MEMORANDUM

To: Site Plan / Subdivision Committee
From: Lauren A. Wasilauski, Open Space & Stewardship Director
Date: April 24, 2023
Re: PB-03-23: Harlingen Associates, LLC
Block 6001 Lots 33, 34, 34.01, 35, 35.01, 36 (Route 206)
Preliminary & Final Subdivision & Site Plan

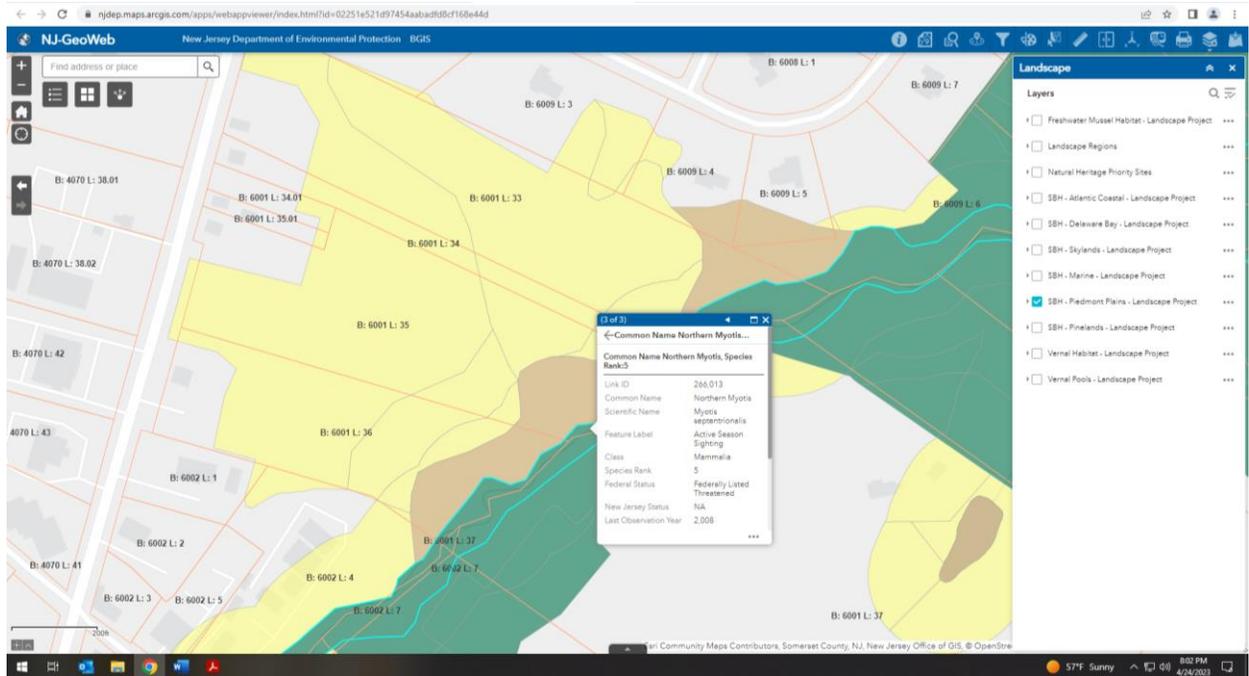
4. Compensation areas for impacts to the wetland transition area are depicted on the plans, but this office could not locate any compensation area(s) for the wetland swale disturbance described in item 3 above. The Applicant should provide testimony regarding NJDEP's requirements regarding this disturbance.
5. Habitat for the federally listed Northern Myotis bat and State endangered Bald Eagle is located at the rear of the property (eastern portion) and continues north and south and along the Fox Brook stream corridor (see screen grab below from NJDEP Geo Web application).

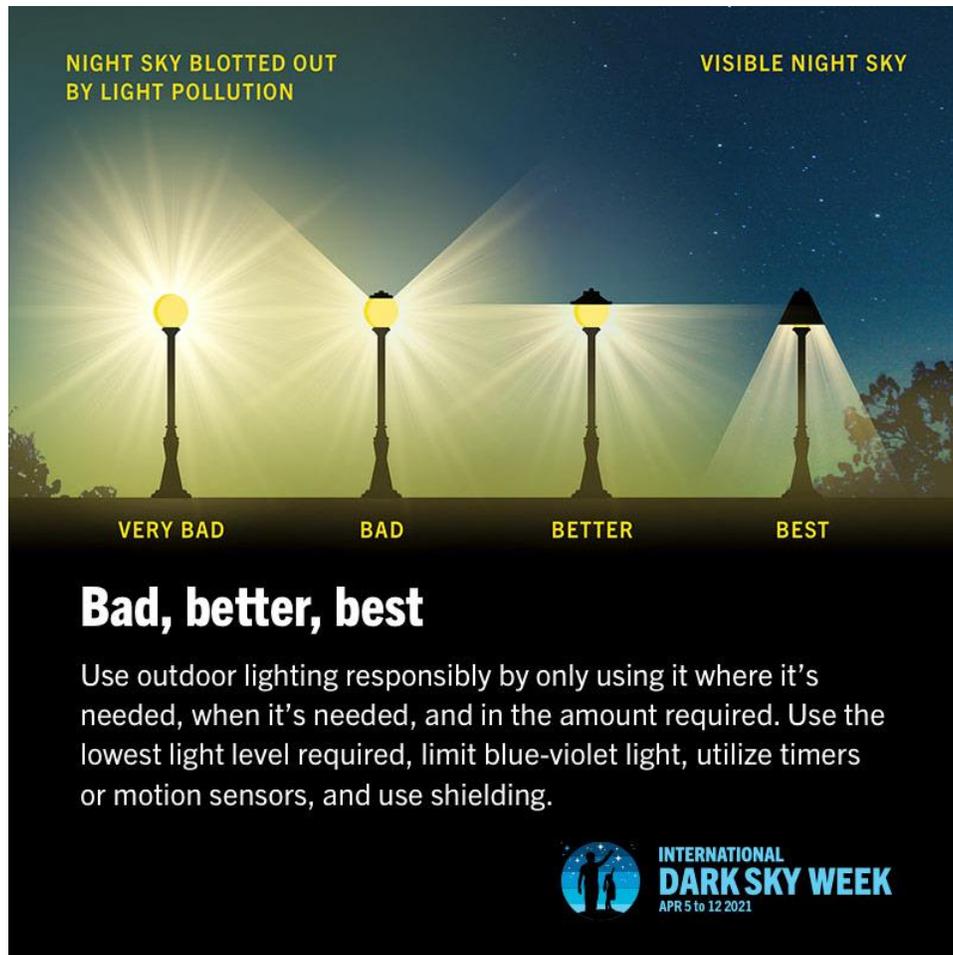
1. On sheet 12, a site identification sign detail is shown with a detail for an LED floodlight.
 - a. This light should not be ground mounted and pointed upward as most of the light is wasted. Instead, the light should be mounted at the top of the sign and pointed down. Shields should be added where possible to only direct lighting onto the sign and to minimize any spillover to surrounding areas.

- b. The lighting should utilize a color temperature that is no more than 3000 kelvins.
 - c. These principles should be utilized for any and all signage.
2. The lighting along the streets and around the site shown on sheet 31 as “Beacon Traditional TRA30” should be substituted for a light that downward facing, shielded and utilizes a color temperature no greater than 3000 kelvins.
